Back panel change in Vented Tumble Dryer

DESCRIPTION:

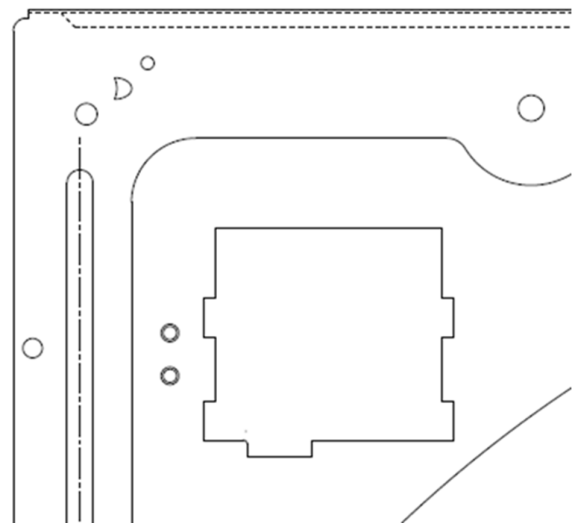
Old type of back panel, spare part number 1254265174, is no longer available. It can be replaced by new one but also power cable with filter has to be exchanged.

1. Old back panel terminal hole.

2. New back panel terminal hole.

Old back panel can be replaced by assembly of new panel and new power cable with filter.
